SUBJECT: Addendum No. 1
City of Lookout Mountain, GA
Chickamauga Trail Pump Station Improvements

ADDENDUM NO. 1

CHICKAMAUGA TRAIL PUMP STATION IMPROVEMENTS

CITY OF LOOKOUT MOUNTAIN, GEORGIA
GEFA LOAN NUMBER: GF2024017
CTI PROJECT NO. G24017-01

TRANSVERSE SECTIONS

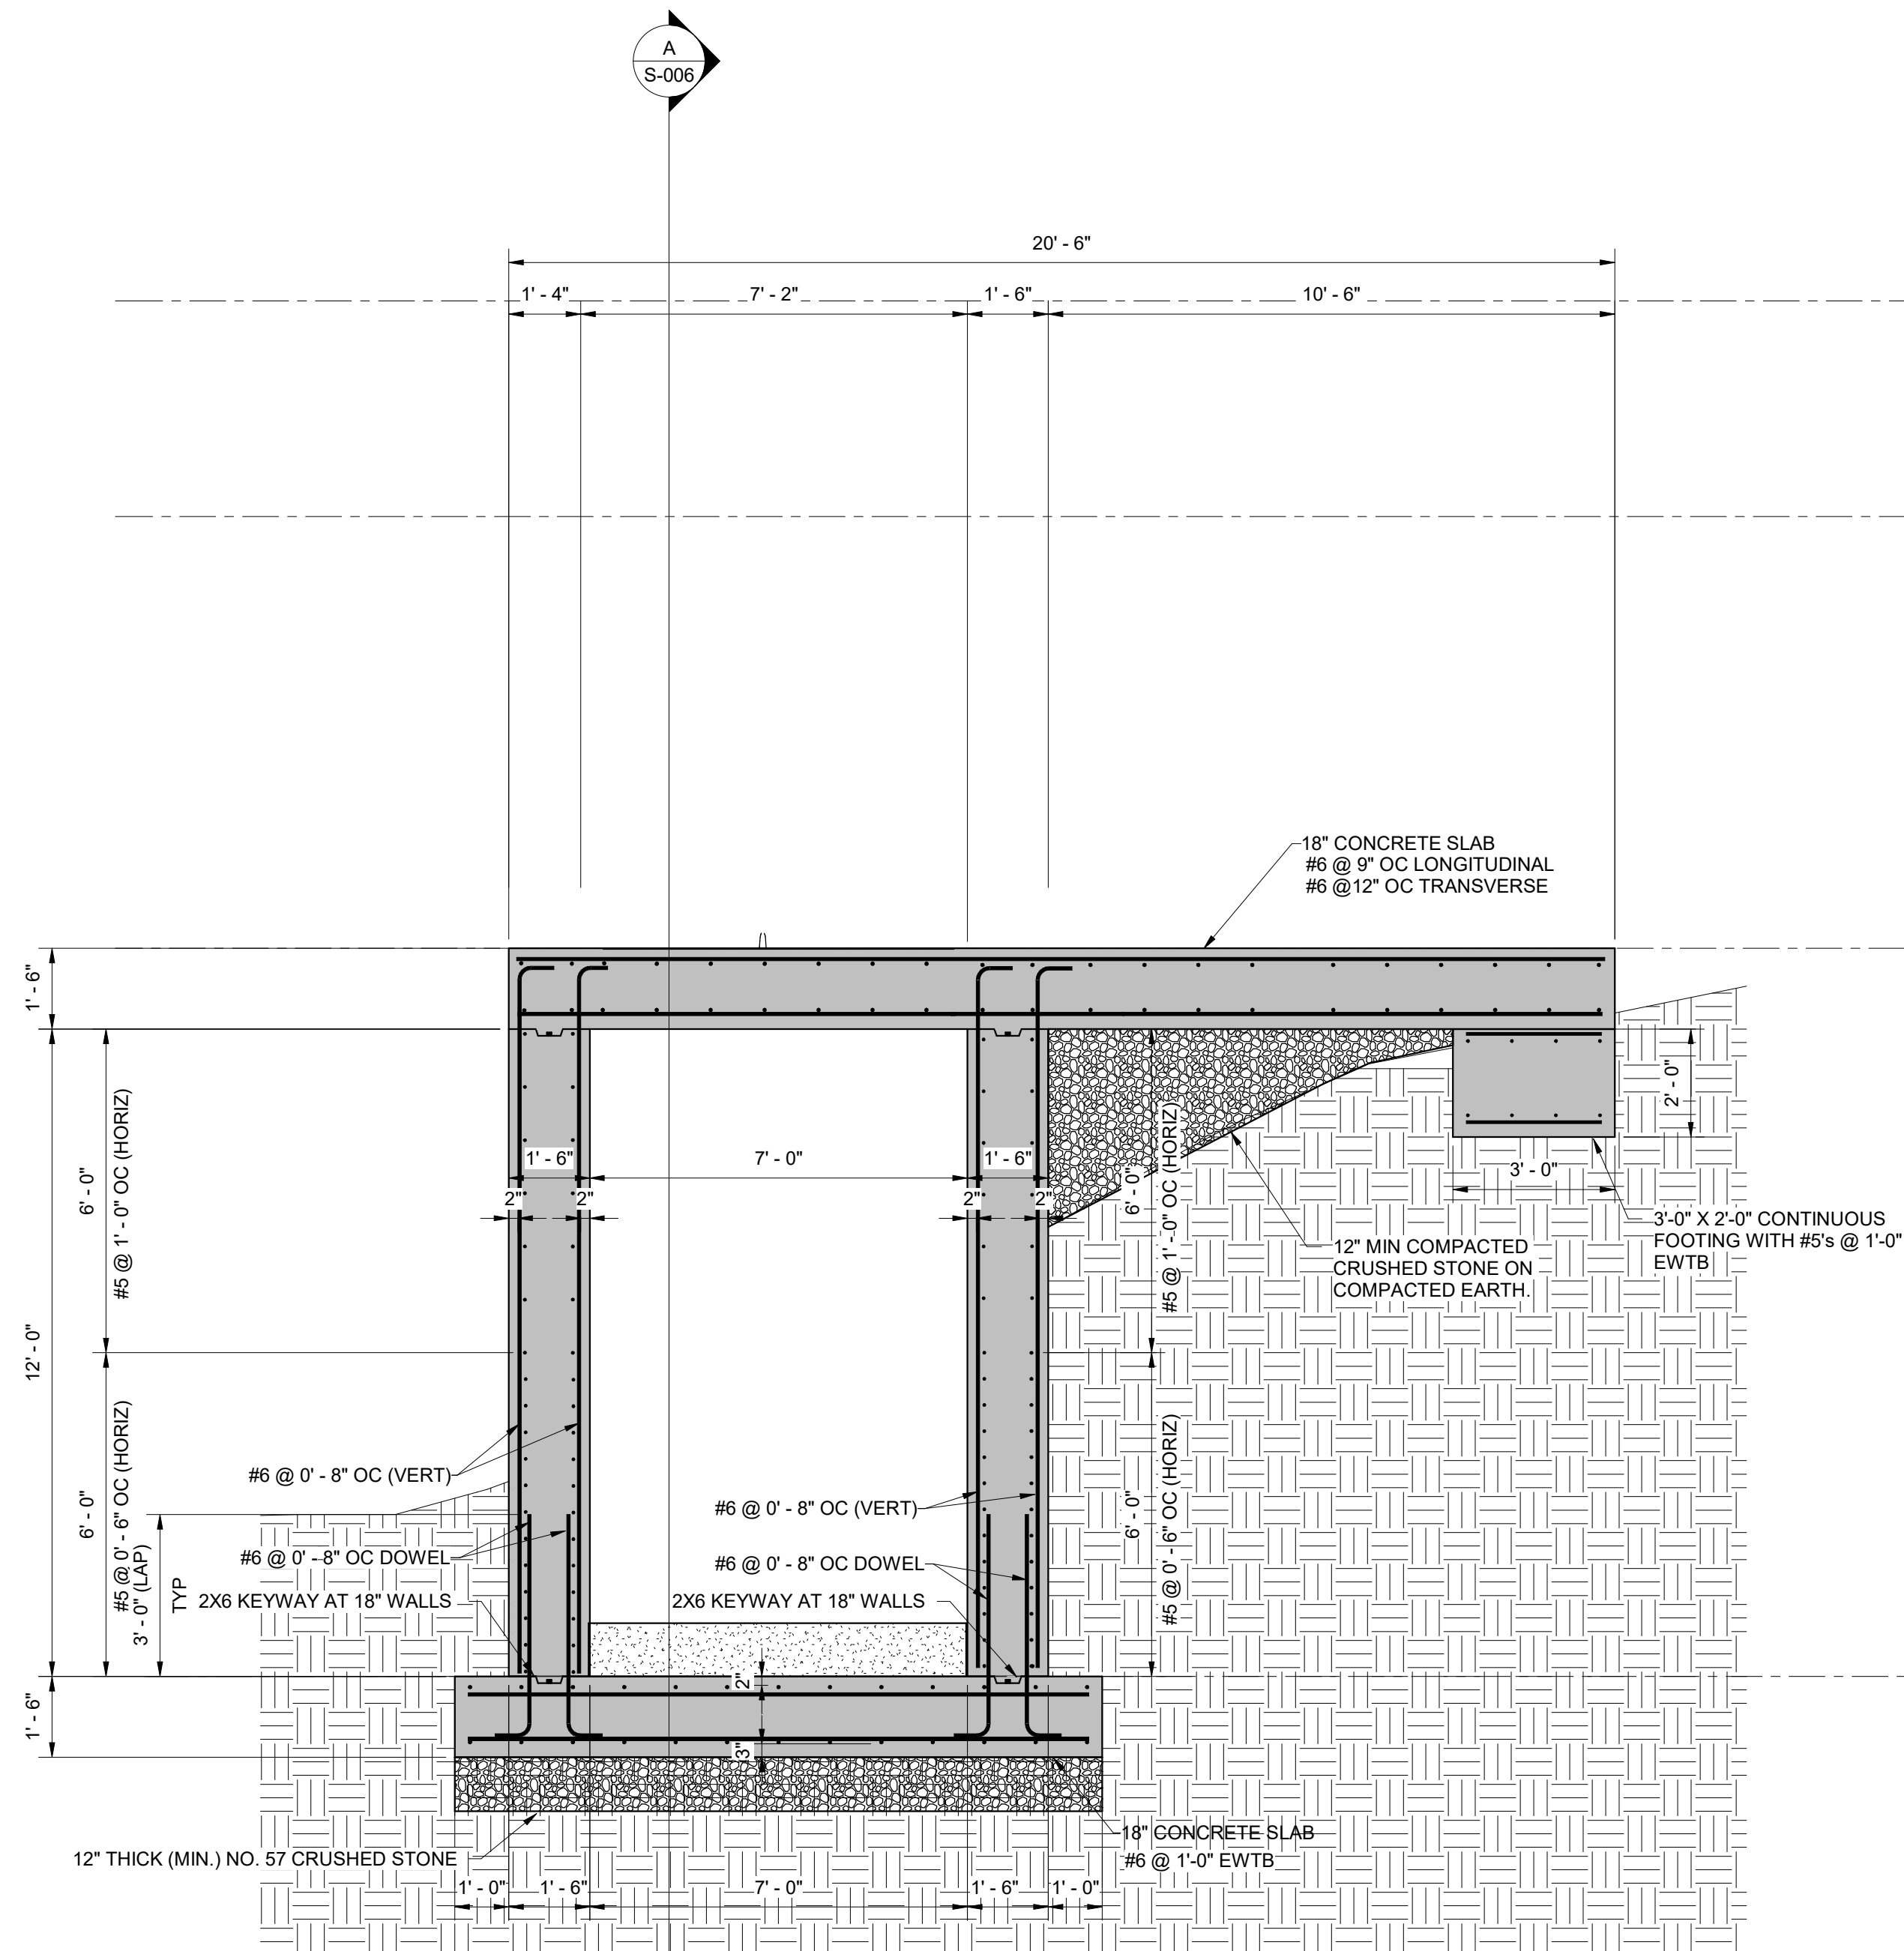
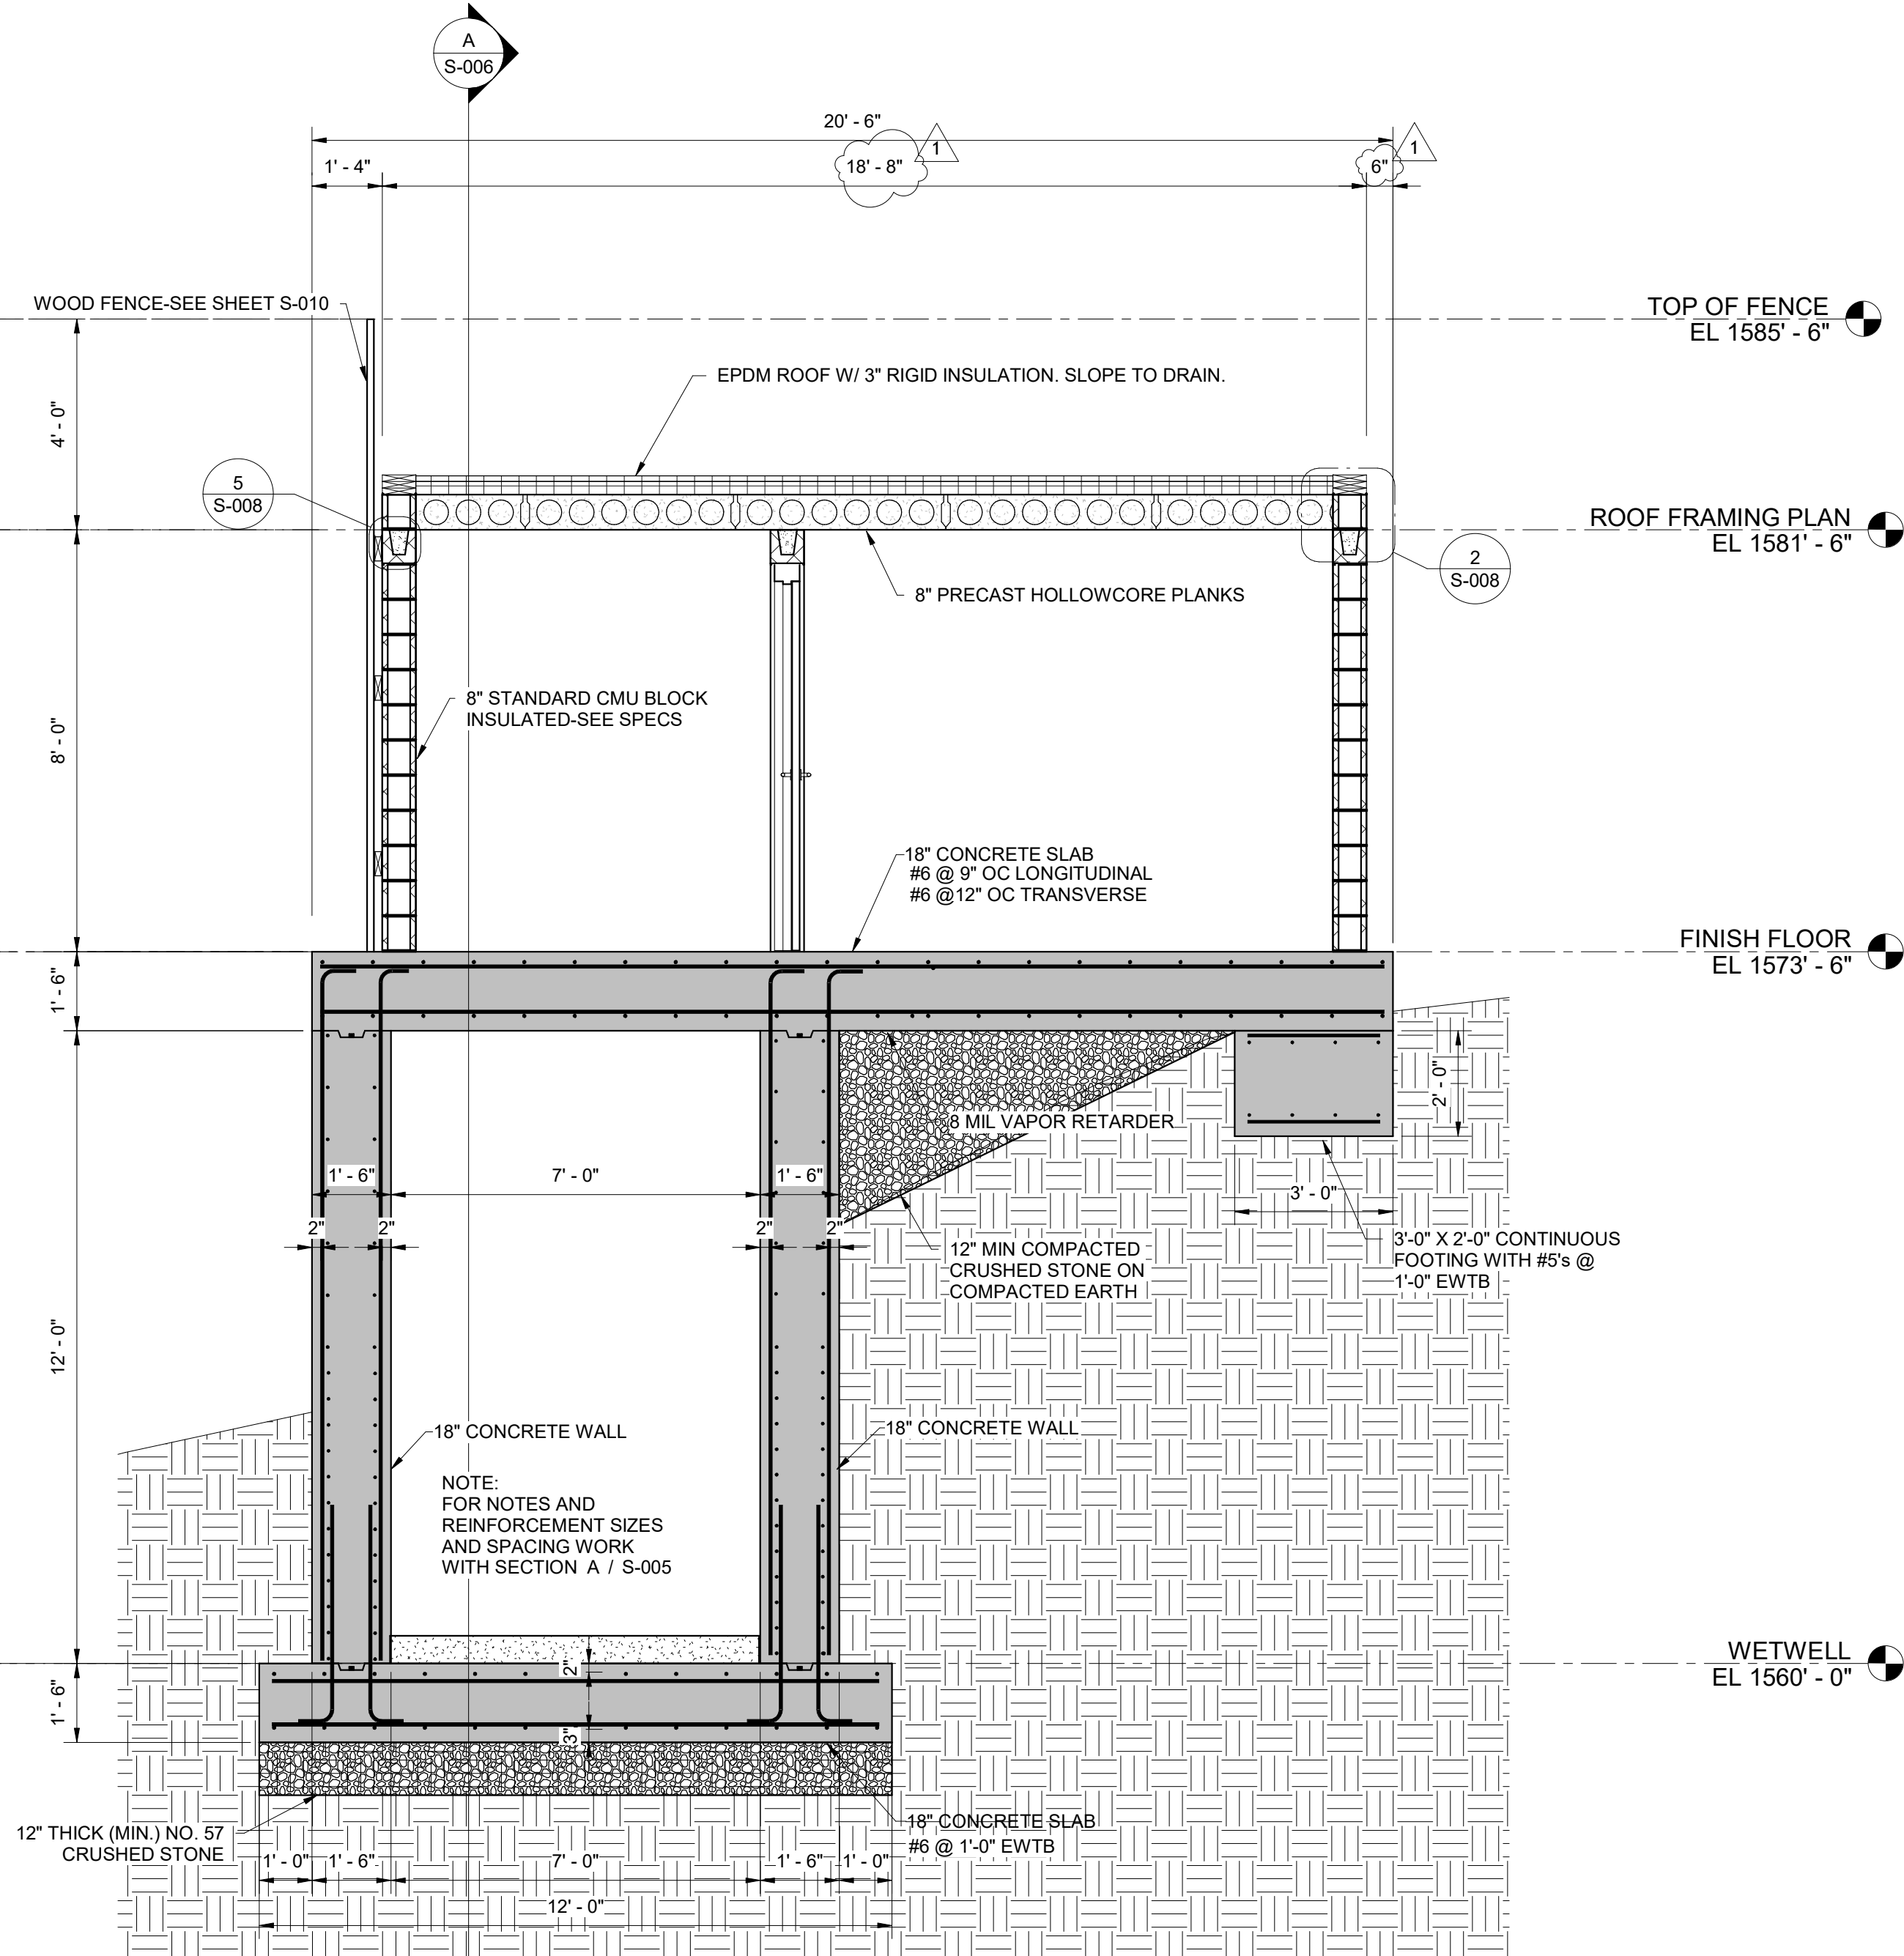
DESIGNED		REVISIONS		BY		DATE		APPROVED	
JBM		DESCRIPTIONS		JBM		08/25		KGP	
DRAWN		1 LENGTHENED MASONRY BUILDING		JBM					
CHECKED									
APPROVED
